# UNITED STATES PATENT AND TRADEMARK OFFICE

APPLICATION NO.	FILING DATE	FIRST NAMED INVENTOR	ATTORNEY DOCKET NO.	CONFIRMATION NO.
10/737,128	12/15/2003	Michael John Rutter	CHM-010	5727
38155	7590	10/04/2005	EXAMINER	
HASSE & NESBITT LLC 7550 CENTRAL PARK BLVD., MASON, OH 45040			PATEL, NIHIR B	
			ART UNIT	PAPER NUMBER
			3743	
DATE MAILED: 10/04/2005

# Office Action Summary

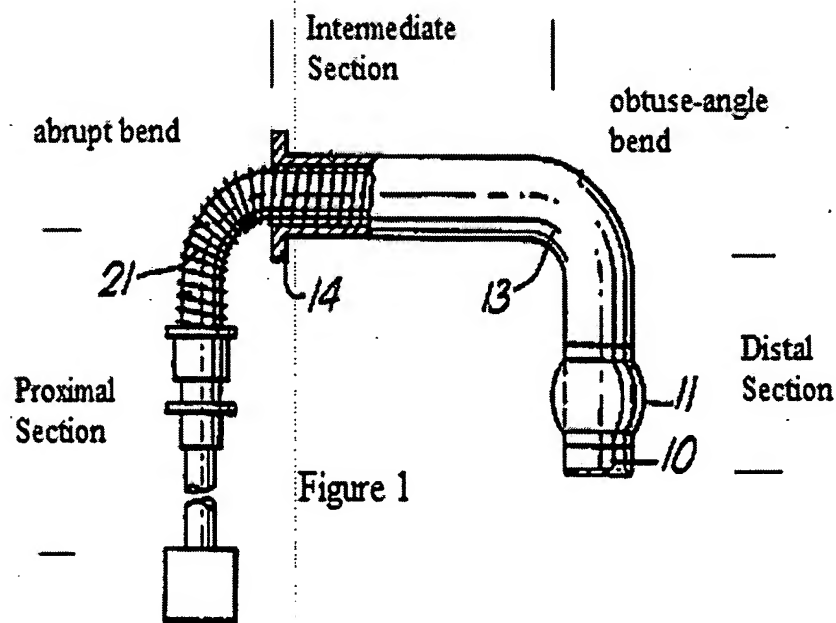
Claims **1 and 3 through 7** are rejected under 35 U.S.C. 102(b) as being anticipated by Inglis et al. (US 5,386,826). Referring to claim 1, Inglis discloses an apparatus that comprises a short distal section of the tubing **10** (see figure 1 below); and intermediate section of the tubing

(see figure 1 below); a pre-formed obtuse angle bend in the tube between the distal and intermediate sections (see figure 1 below); an elongated proximal section of the tubing (see figure 1 below; the examiner would like to point out that the helical coil can be extended to therefore meet the limitations of the ratio of the length of the proximal section to the length of the distal section from about 2.0 to about 4.0); a pre formed abrupt bend in the tube between the intermediate and proximal sections (see figure 1 below); and an inflatable cuff 11 (see figure 1 below) integrated into the distal section of the tubing; wherein the ratio of the length of the distal section to the length of the intermediate section is from about 1.0 to about 2.0 (see figure 1 below).

**Referring to claim 3**, Inglis discloses an apparatus wherein the abrupt bend interconnects the proximal section and the intermediate section along the length of the tube at an angle of from about 80 to about 95 degrees (see **figure 1 above**).

**Referring to claim 4**, Inglis discloses an apparatus wherein the abrupt bend interconnects the proximal section and the intermediate section along the length of the tube at approximately a right angle (see **figure 1 above**).

**Referring to claim 5**, Inglis discloses an apparatus wherein the distal section, intermediate section and the proximal section extend the same general plane (see **figure 1 above**).

**Referring to claims 6 and 7**, Inglis discloses an apparatus wherein the distal section, intermediate section and the proximal section are substantially rectilinear in formation (see **figure 1 above**).

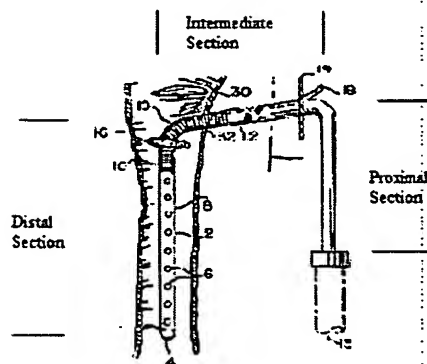
Claims **1, 3 through 11, 15, 17 and 26** are rejected under 35 U.S.C. 103(a) as being unpatentable over Beck, Jr. et al. (US 5,339,809). **Referring to claims 1, 3 through 11, 15, 17 and 26**, Beck discloses the applicant's invention as claimed with the exception of providing a tubing that comprises a ratio of the length of the distal section of the tubing to the length of the intermediate section of the tubing being about 1 to about 2/1.2 to about 1.8 and the ratio of the

length of the proximal section of the tubing to the length of the distal section of the tubing being about 2 to about 4/2.5 to about 3.5. Since Beck discloses accordion pleats 10 between the intermediate section and the distal section (see figure on the next page) it would have been obvious that the length of the distal section and the intermediate section can be adjusted to any desired ratios even to the ones claimed in claims 1, 17, 23 and 26. The examiner also reviewed the applicant's specification and discovered that the applicant has not established any criticality on why the ratio between the length of the distal section to the length of the intermediate section must be 1 to about 2/1.2 to about 1.8 and the ratio between the length of the proximal section to the length of the distal section must be 2 to about 4/2.5 to about 3.5. Since the applicant has not established any criticality the ratios are considered a simply matter of design choice and therefore it would be obvious to one in the ordinary skill of the art that through mere routine experimentation could arrive at the claimed length ratios, because one of ordinary skill in the art would have known that different ratios are required for different user's and in different procedures being performed (i.e., pediatric, infant, adolescent, adult, elderly, thin, obese, patients) and such users would require different ratio lengths of the sections of the tracheotomy tube in order for the tube to be used in different situations and with different users.
